**STAFF REPORT: NOVEMBER 10, 2021 MEETING**

**APPLICATION NUMBER: 21-7586**

**ADDRESS: 1713 SEYBURN**

**SCOPE: REPLACE SIDE AND REAR ENTRANCE DOORS**

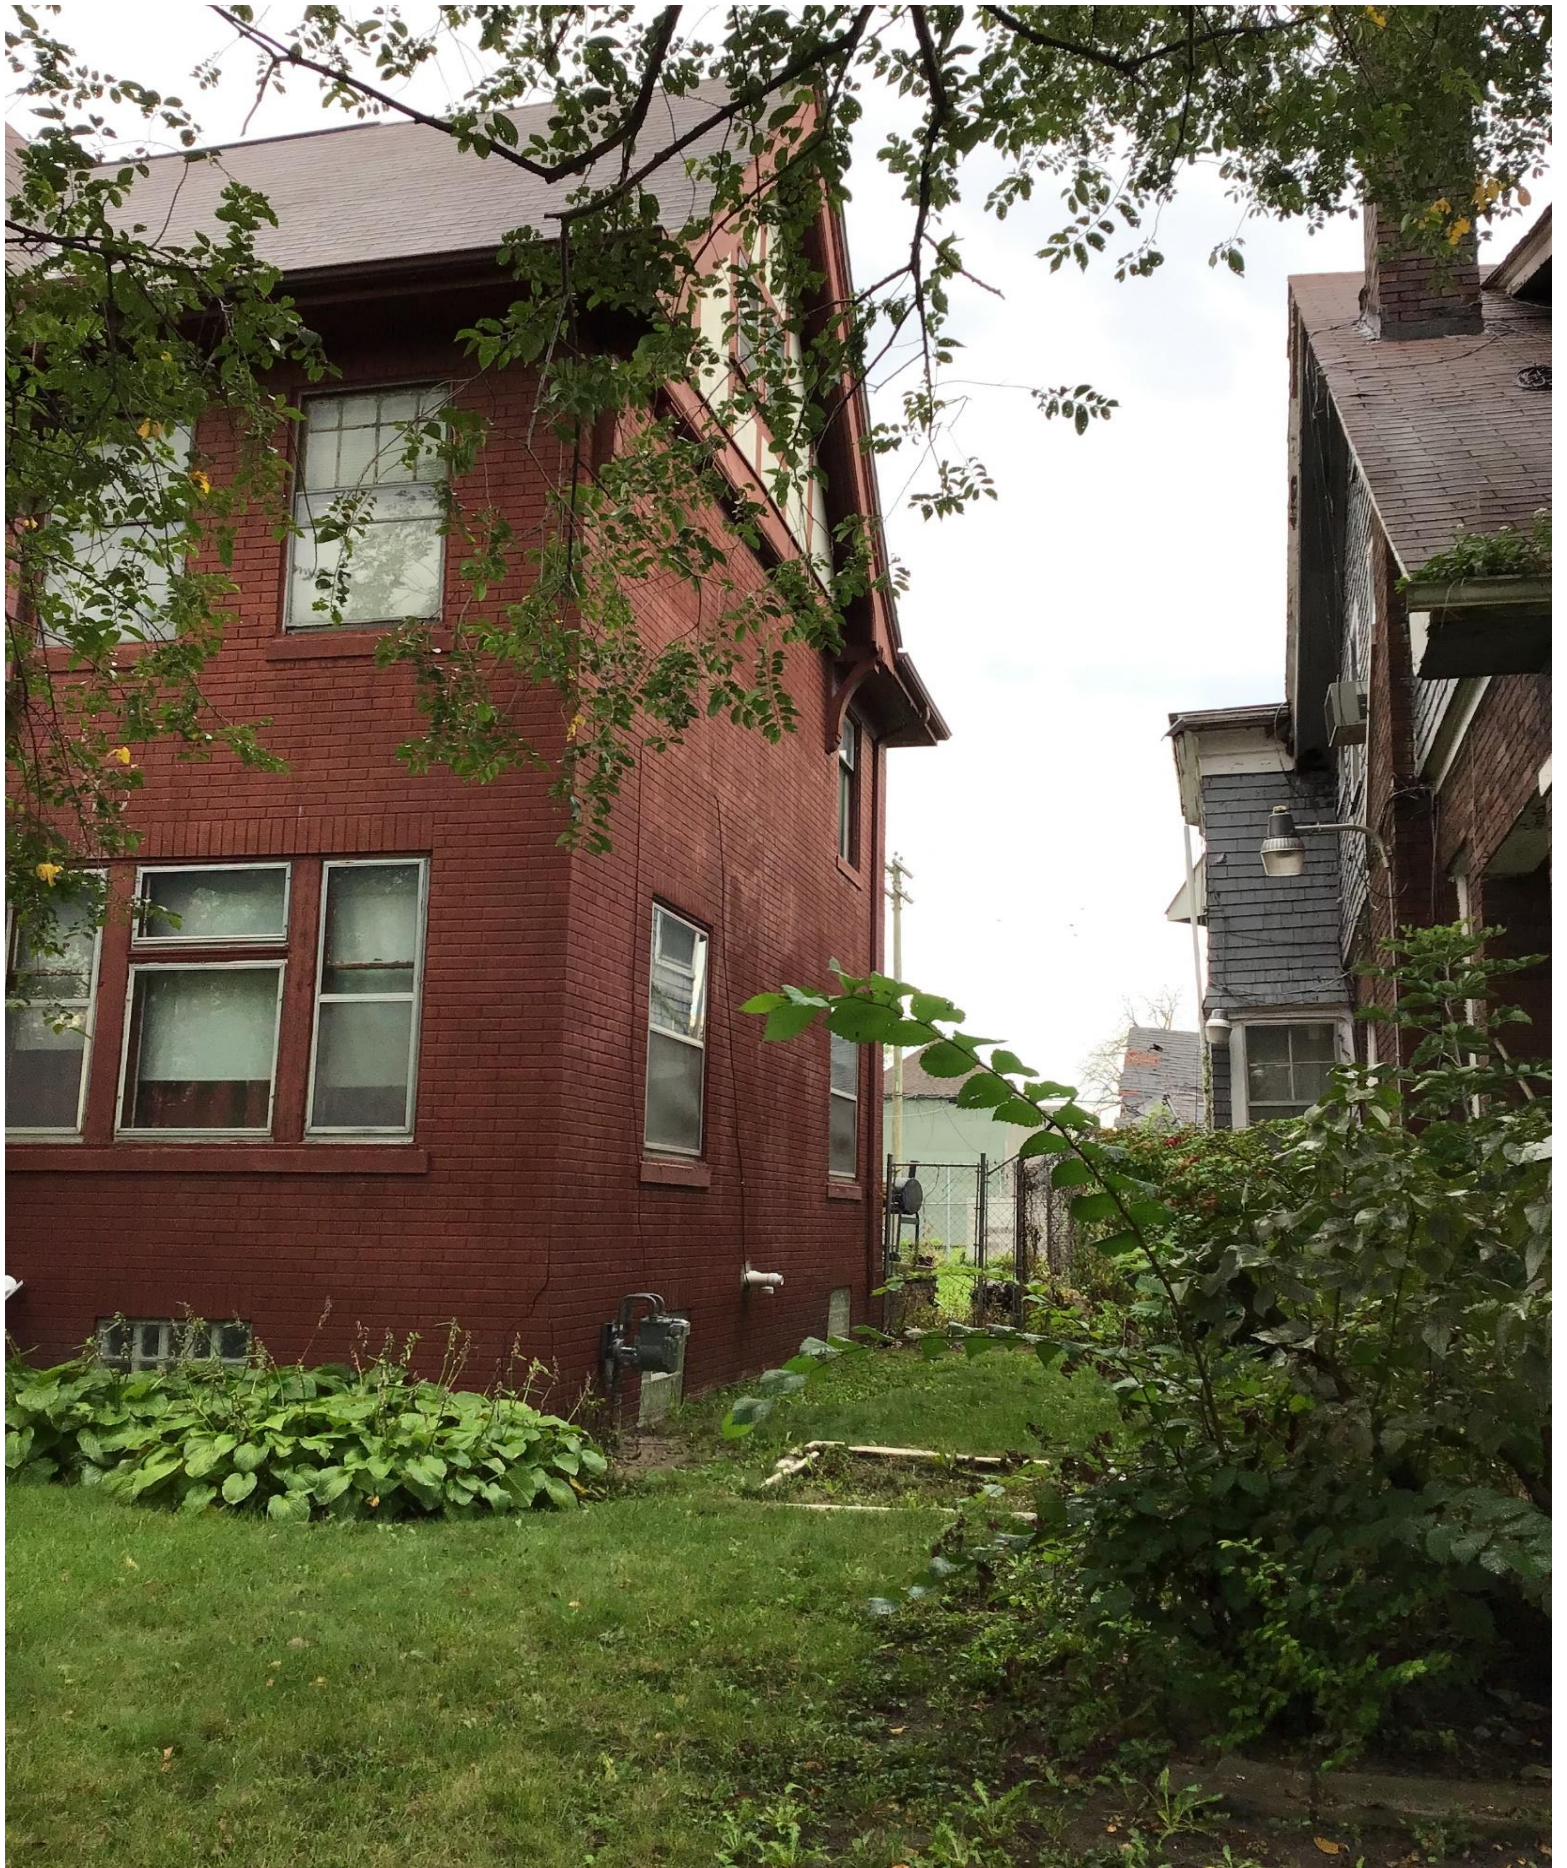
**Side Entry door - (Current)** Solid wood interior door, exterior is delaminating (see pictures). Dead bolt looked to be added on (you can see where the deadbolt use to be on the frame). Door is a dark wood finish.

**Side Entry door - (Replacement)** New steel door (slab and frame) with storm door. New color is snowmist white with a diamond shaped glass in the top (will match back door).

**Back Entry Door - (Current)** - Door doesn't have door knobs or dead bolts, just 6-7 barrel locks on top, bottom, and middle to keep door locked/closed. Back door wouldn't open for us, they tried to kick it open from exterior and door wouldn't open. The storms will open but they do not lock or have handles on them any longer. Door is a white exterior (aluminum colored storm door covering it).

**Back Entry door - (Replacement)** New steel double doors with door handles and dead bolt. No storm door on this. New door will be snow mist white with a diamond shaped glass in the top of each door panel (Double Door like existing).
